# Access Compliance Report

## Public Rights-of-Way

Intersection ID: 30006	Main Street: FULLERTON_CT	Cross Street: OAKBORO_LN	Location: SE
ADA ID: 51A73A41F726	Ramp Type: PerpDiag	Initial Pass/Fail: Fail	Overall Compliance: No
Severity Score: 25			
Codes/Mitigation Info/Possible Solution		Field Measurements/Component Compliance

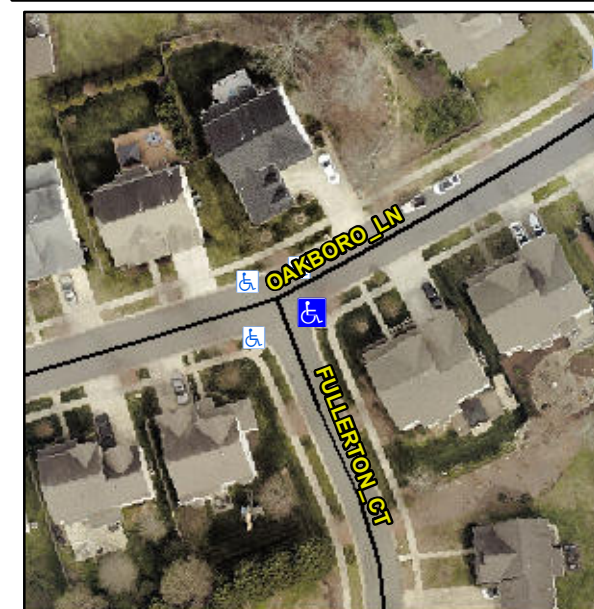
**Not Found, R304.5.3**

Compliance	Description	Data	Compliance	Description	Data
N/A	Ramp Length (in)	70.0	Yes	Ramp Slope (%)	7.0
Yes	Ramp Width (in)	48.0	No	Ramp XSlope (%)	11.2
N/A	Flare Type LT	N/A	N/A	Flare Type RT	N/A
N/A	Flare Slope LT (%)	N/A	N/A	Flare Slope RT (%)	N/A
N/A	Flare Traversable LT?	N/A	N/A	Flare Traversable RT?	N/A
N/A	Landing Length (in)	N/A	N/A	DWS Provided?	N/A
N/A	Landing Width (in)	N/A	N/A	DWS Contrast?	N/A
N/A	Landing Slope (%)	N/A	N/A	DWS Length (in)	N/A
N/A	Landing X Slope (%)	N/A	N/A	DWS Full Width?	N/A
N/A	Landing Curb? (Y/N)	N/A	N/A	DWS Offset (in)	N/A
N/A	Shared Landing?	N/A			
N/A	Gutter Ponding?	N/A	N/A	Gutter Slope (%)	N/A
N/A	Gutter Lip Ht (in)	N/A	N/A	Gutter X Slope (%)	N/A
N/A	Painted X Walk1?	No	N/A	Painted X Walk2?	No
	X Walk 1 Direction	To N		X Walk 2 Direction	To W
N/A	X Walk 1 Width (in)	N/A	N/A	X Walk 2 Width (in)	N/A
	X Walk 1 Slope (%)	3.8		X Walk 2 Slope (%)	1.2
	X Walk 1 X Slope (%)	5.3		X Walk 2 X Slope (%)	5.8

**Remove & Replace Curb Ramp With Two New Directional Ramps or Equivalent.**
